Central Zoo Authority

F. No. 19-58/93-CZA(190)(Vol.III)(M)/422/

Sub:- Design for the construction of various enclosures at Manipur Zoological Garden, Imphal, Manipur.

Design for the proposed construction of Leopard Cat Enclosure with Night Shelter at Manipur Zoological Garden ,Imphal

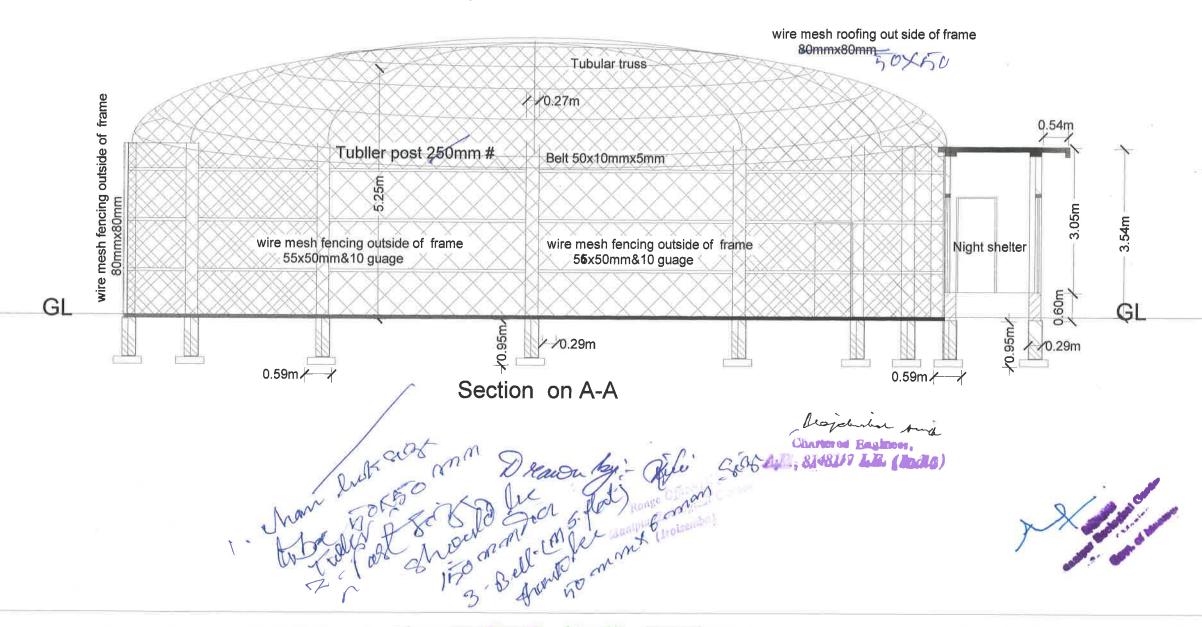
3. <u>Leopard cat enclosure:-</u>

The design was scrutinized and approved. However, following corrections are required in the design of this enclosure:

- a) In the night cells, connecting doors marked as D-1 should be of sliding doors
- b) Doors marked as D should be hinged door opening in the gallery not inside the cell.
- c) Doors opening inside the paddock should be draw up doors to be operated from the keepers gallery.
- d) There should be 2.1 mtrs. wide Keepers' gallery at the back of the night cells with door opening at one side of the gallery.
- e) There should be a top closed (with chain link) kraal provided on the other side of the door of the gallery measuring about 34 mtrs.
- f) Chainlink used should be of 50x50 mm X 10 gauge instead of 55 mm. Perhaps wrongly typed in the letter issued from this office. Same chain link—should be used to cover the entire enclosure instead of using common size (80mm X 80 mm) mentioned in your design.

Keeping in view of the above, you are requested to submit amended copies of the designs for further scrutiny by this Authority and its authentication of approval and record.
